AMENDED SITE PLAN

BUCKS FLOWER GARDEN

Re: Family Trust Bukov d/b/a Buck's Flower Garden
65 Bedford Banksville Road, Armonk

Regarding the above captioned, the following are our responses to the Staff Report Comments, dated November 23, 2021:

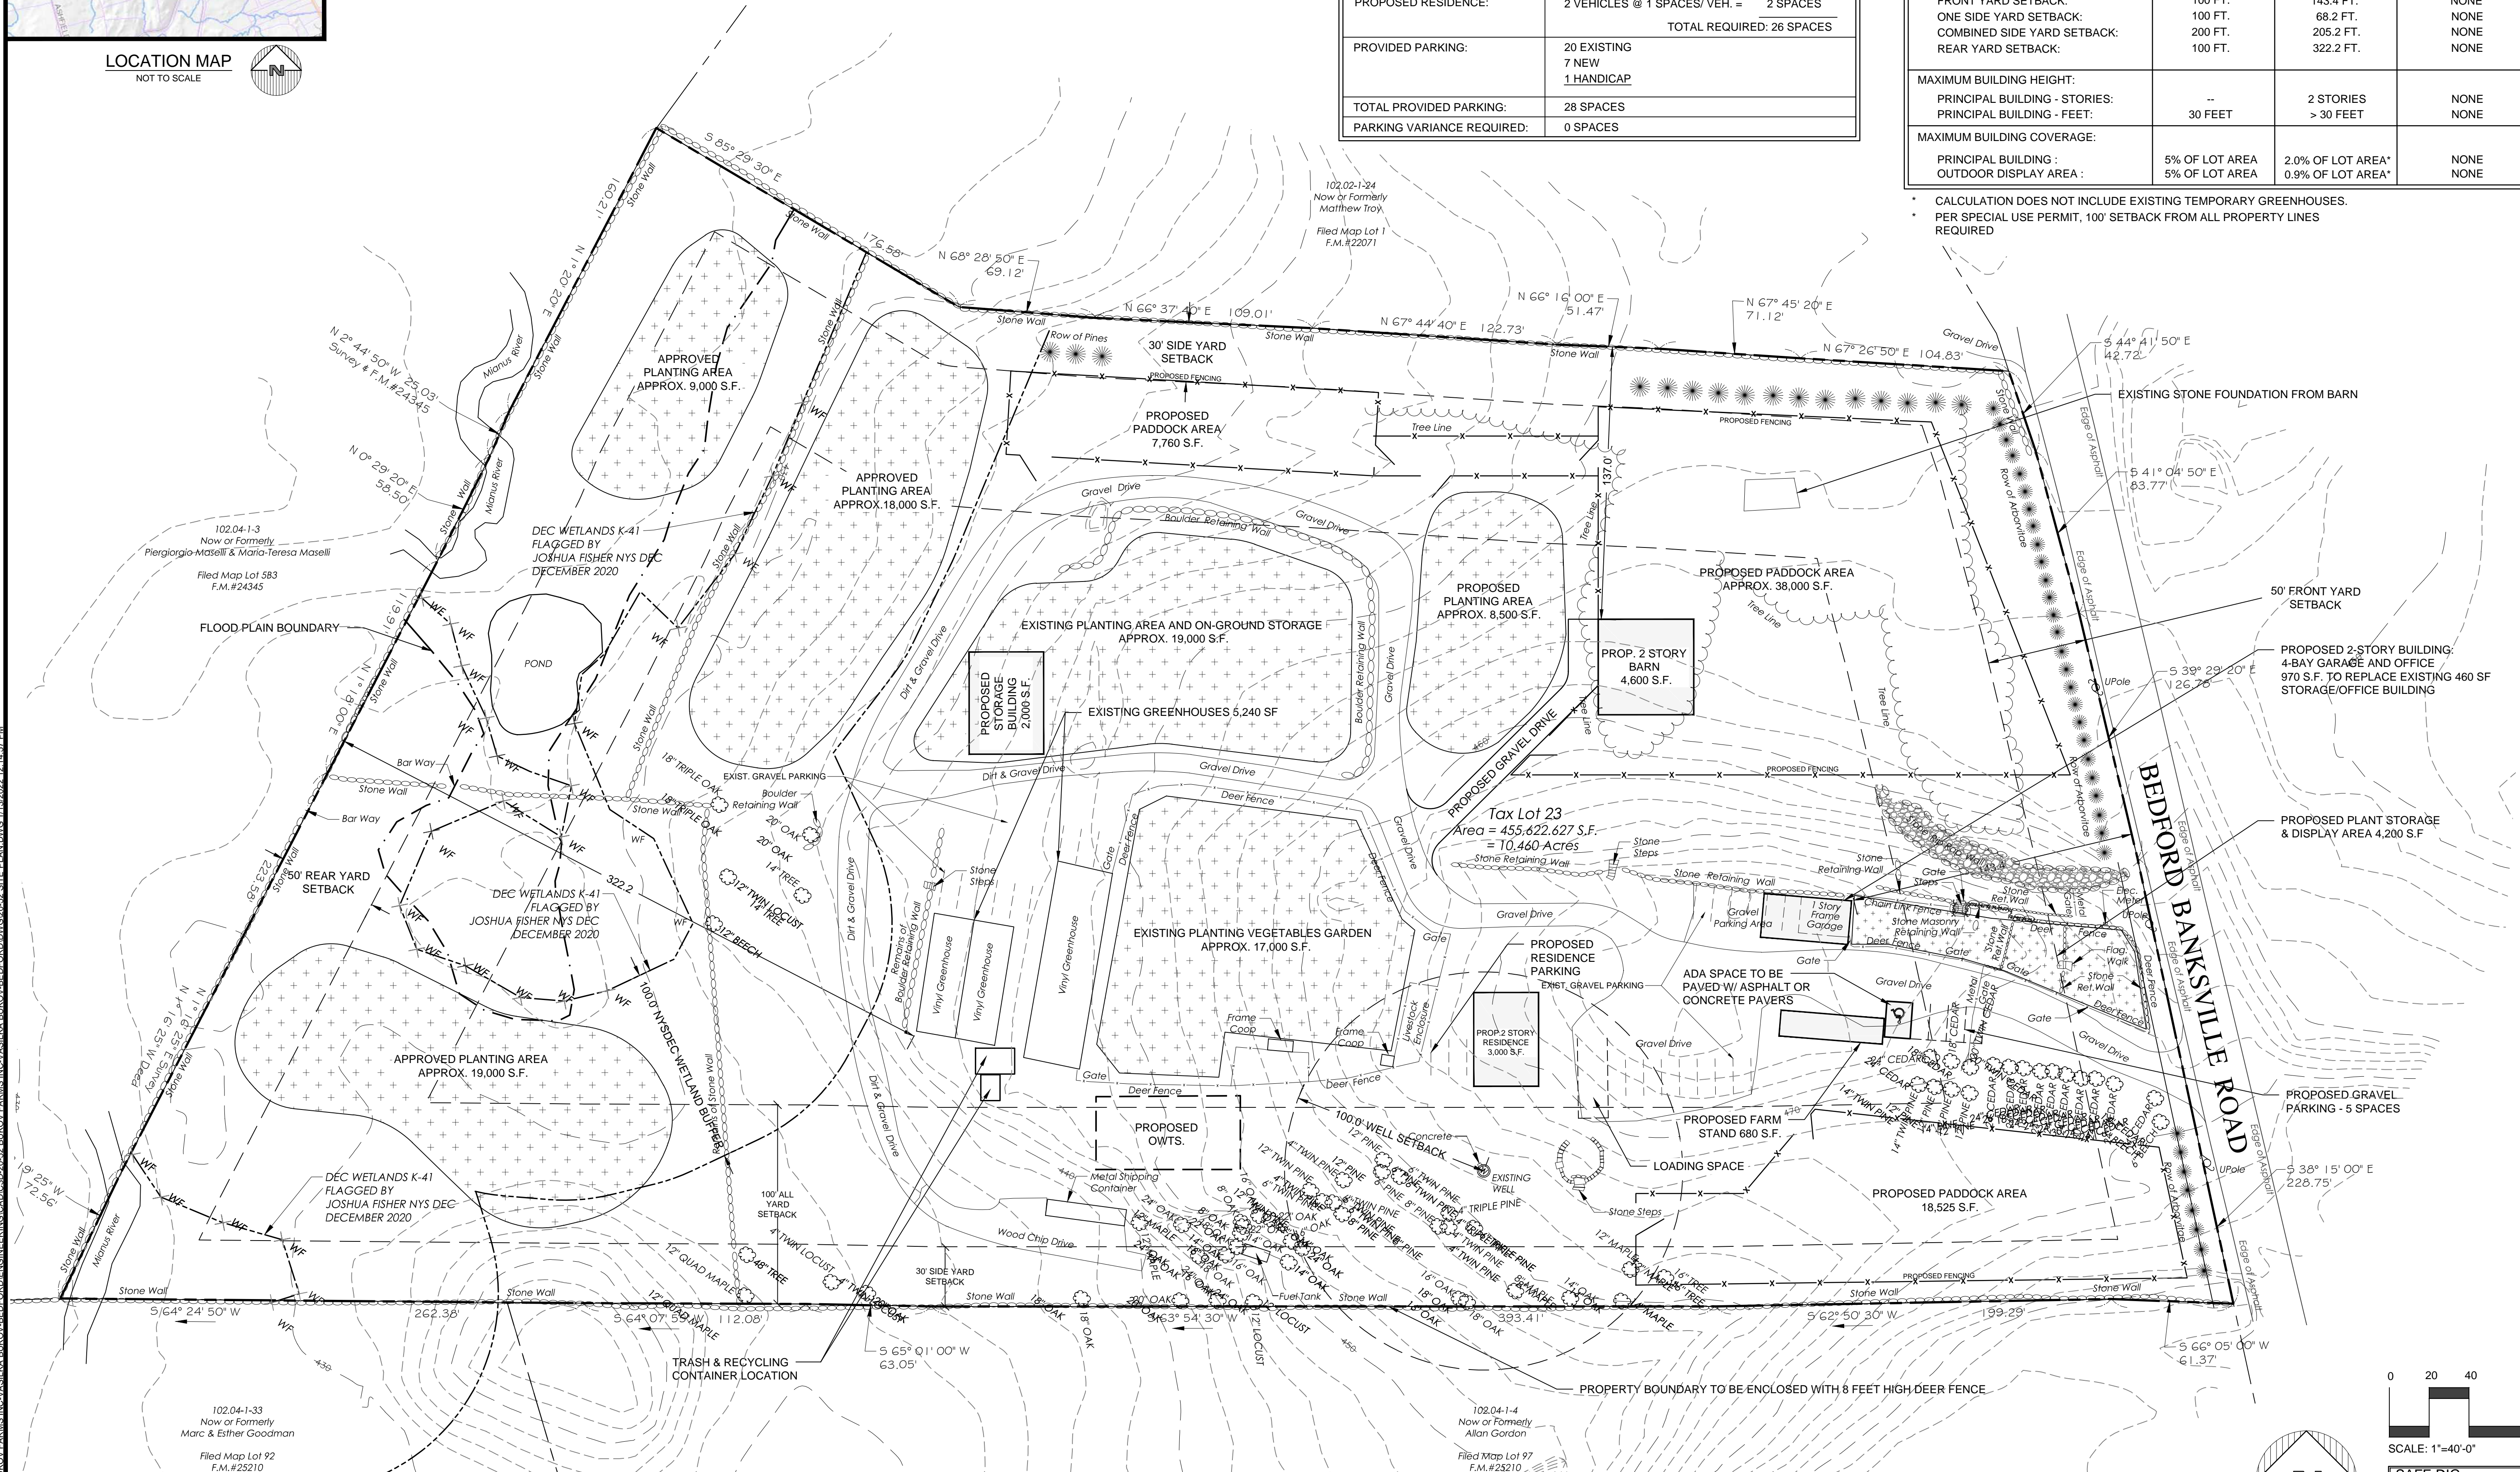
2. Pursuant to Section 355-40.F(2)(a)[2] of the Town Code, outside sales and display areas are limited to a total of 5% of the lot area. The Applicant should calculate the outdoor sales and display area. If larger than 5% of the lot area, the outdoor sales and display area should be reduced in size.

12. It is noted that the existing special use permit for the nursery use prohibits structures within 100 feet of any lot line. The submitted site plan does not comply with this existing special use permit requirement.

14. It is noted that the existing special use permit for the nursery use prohibits nursery plantings nearer than 100 feet from any water course. The submitted site plan depicts several planting areas labeled "approved planting areas" that are located within the 100-foot buffer area. It appears that these areas don't comply with the previously approved special permit and should be removed.

4. The off-street parking analysis should be revised to include the off-street parking requirements for the proposed residence.

13. The Applicant should submit a Building Coverage exhibit for review.

15. Pursuant to Section 355-58 of the Town Code, the plans shall be revised to include a loading space.

17. Pursuant to Section 355.15.O of the Town Code, the site plan shall be revised to depict details of the proposed refuse and recycling area.

Response: the display area is 1% of the total site area which is noted in the Zoning Schedule on the Site Plan.

Response: The proposed storage building has been relocated to comply.

Response: We would like to discuss this further. There seems to be a conflict between this condition and the condition discussing plantings in the low-lying area and the signed site plan.

Response: This information has been added.

Response: A building coverage schedule has been added to the Site Plan.

Response: Although it is not necessary for the operation of the property, we have provided a loading space.

Response: A location is shown behind the greenhouses for the trash containers to be placed.
